Technical Service Bulletin: TSB200252

Released Date: 28-Aug-2023

New Oversized Cylinder Head Gaskets

Figure 1, Existing Oversized Cylinder Head Gasket Design Showing Notch at Bottom Left (For Differentiation Purposes Only).

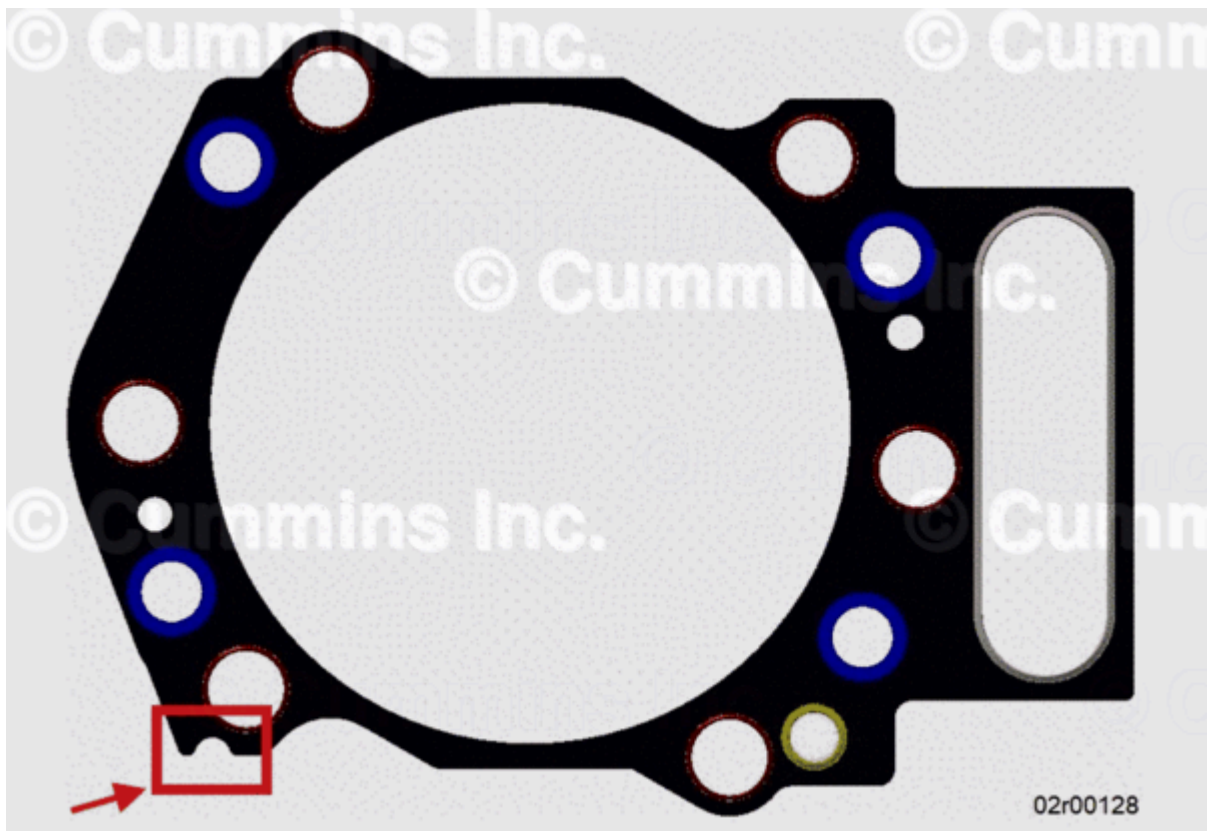
For remaining stock of the existing cylinder head gasket design, Figure 1 below has been included for reference. Note there are no notches at the top right corner, but a notch at the bottom left corner is still present, this is a 0.5mm oversized gasket.

Figure 2, New 0.25 mm Oversized Cylinder Head Gasket Showing One Notch at Upper Right.

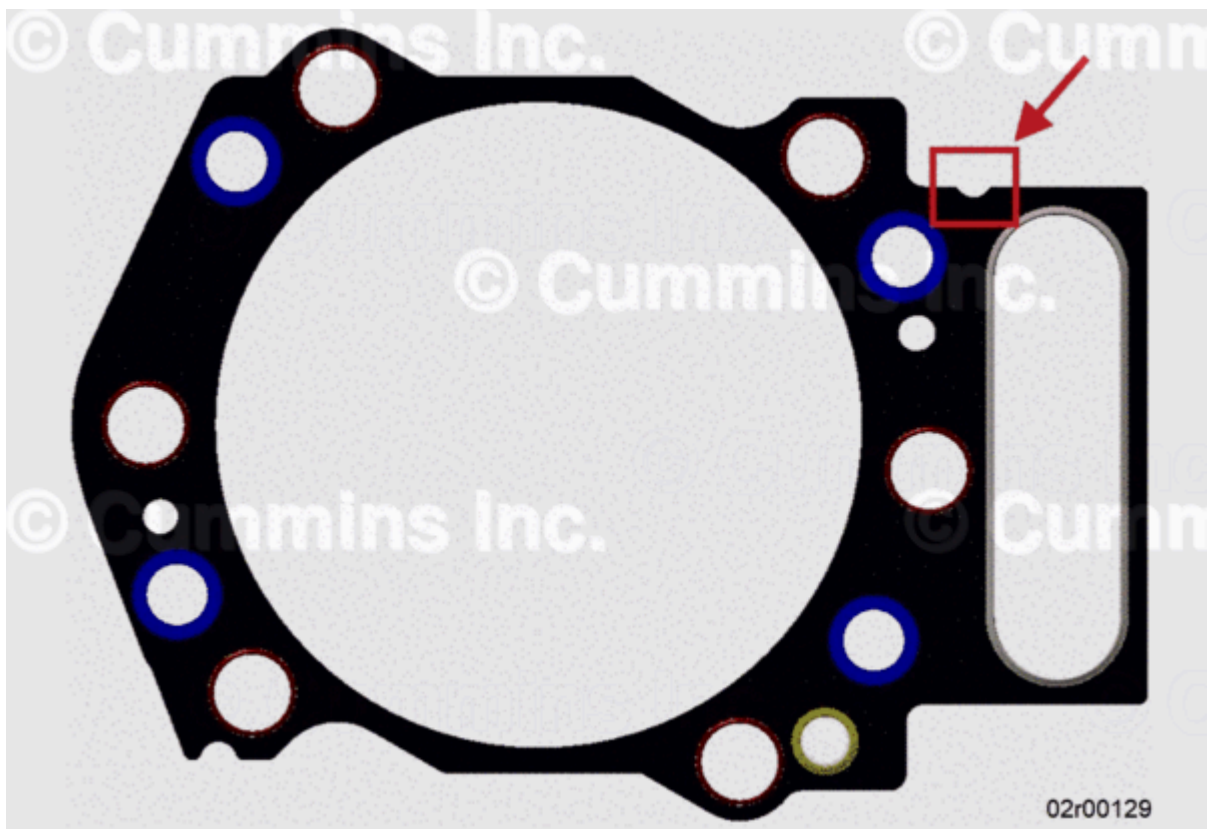
In addition to the already-available 0.5 mm oversized cylinder head gasket, a 0.25 mm and 0.75 mm oversized gaskets are available. There are new identification features on these oversized gaskets in order to differentiate them:

- All oversized cylinder head gaskets have a single isolated notch (shown in bottom left corner of Figure 1 below)
- The number of notches in the opposite corner of the cylinder head gasket represent the size:
 - 0.25mm oversized cylinder head gasket has one notch in this area
 - 0.5mm oversized cylinder head gasket has two notches in this area
 - 0.75mm oversized cylinder head gasket has three notches in this area
